**PLAINS EXPLORATION AND PRODUCTION
CONDITIONAL USE PERMIT D010386D
(PHASE IV DEVELOPMENT PLAN)**

ADDENDUM TO FINAL ENVIRONMENTAL IMPACT REPORT

Prepared for:
County of San Luis Obispo
Department of Planning and Building

6.0 RESPONSE TO COMMENTS

CROSS-SECTION C-D
FIGURE 5

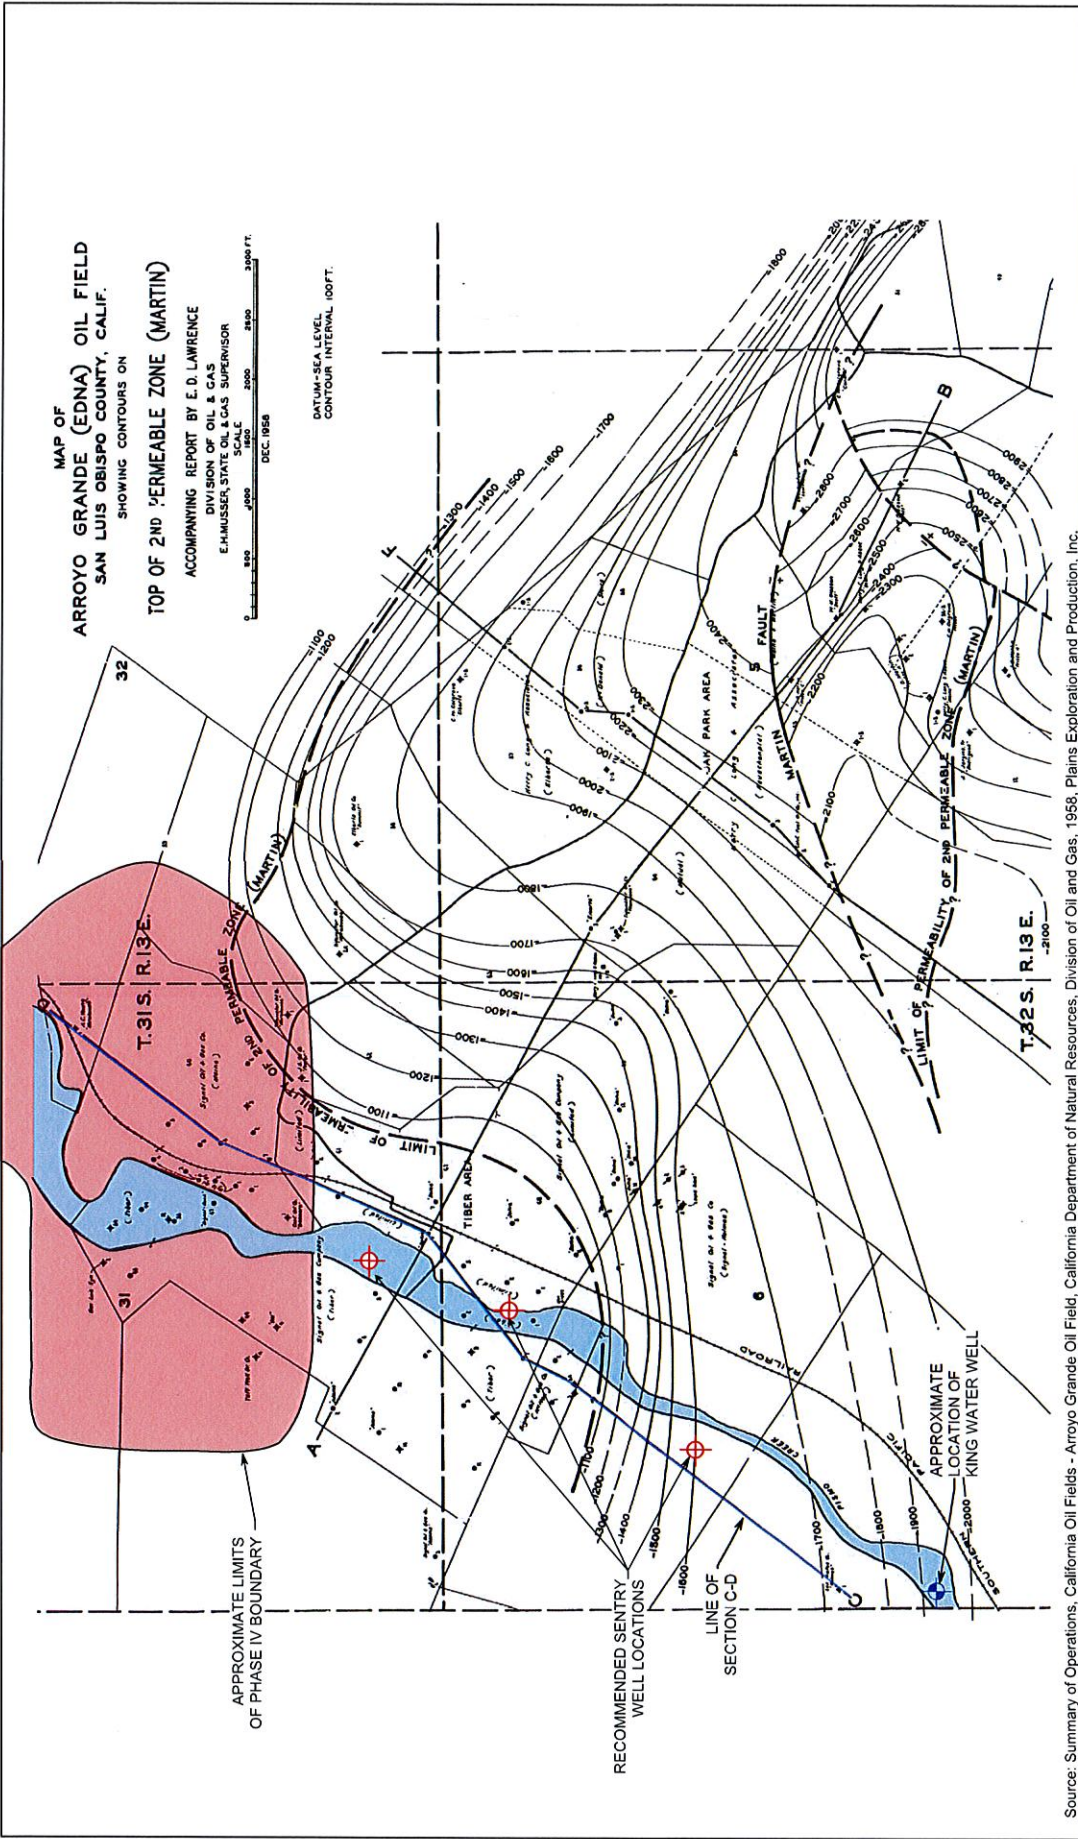
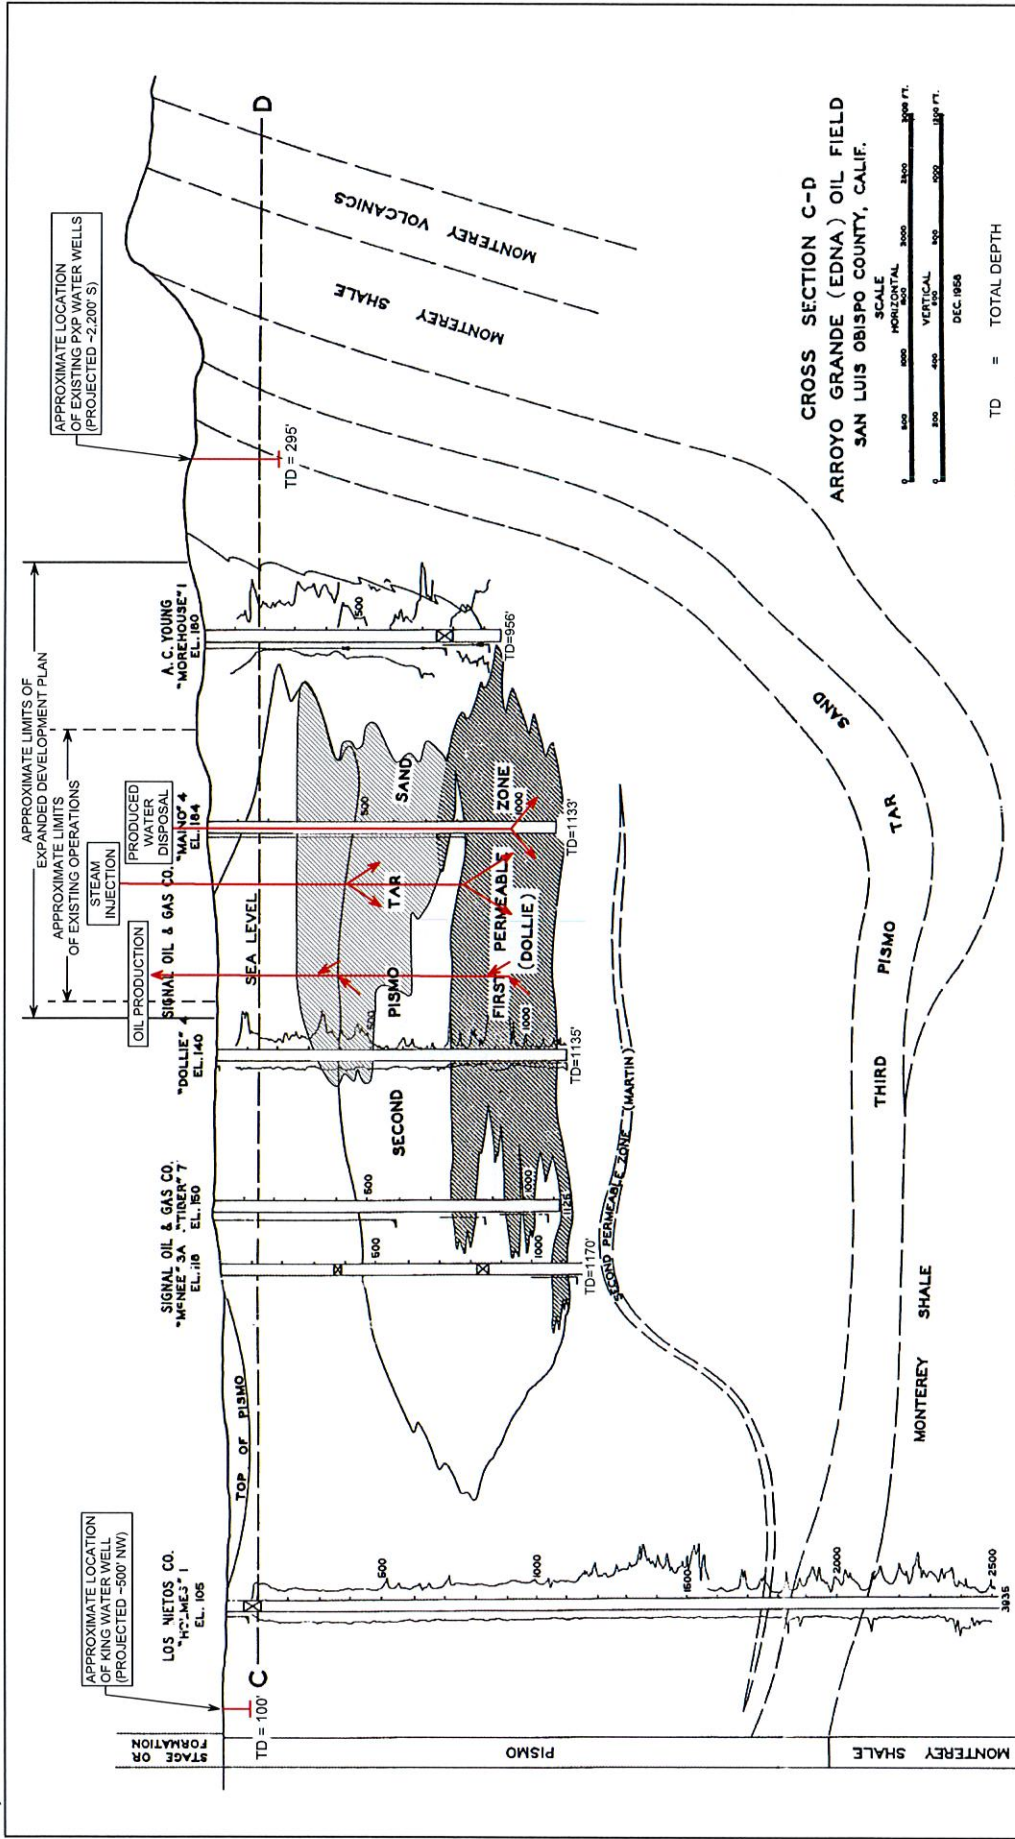
The Padre report maps and cross sections are not consistent with respect to the area of the operation and do not show the entire area. Figure 4 cuts off the northern portion of the Phase IV development. The Cross-Section shows the development area extending 600 feet further south than the map on Figure 4. Figure 1 shows the development area extending 2000 feet further west than what is shown on Figure 4.

As depicted on Figures 4 and 5, the KWW (closest water wells) is located greater than one mile south of the southern boundary of the PXP Phase IV Development Plan area, and the targeted production / injection zones of the KWW and other water wells and PXP's oil production activities are separated vertically by a minimum of approximately 700 feet. Based on the lateral distance between the KWW and other water wells and PXP's oil production activities, as well as the vertical separation between the targeted, separate production zones, it is unlikely that the oil production activities proposed by PXP will adversely impact the quality of the groundwater contained within the alluvial aquifer that is produced at the KWW and other water wells.
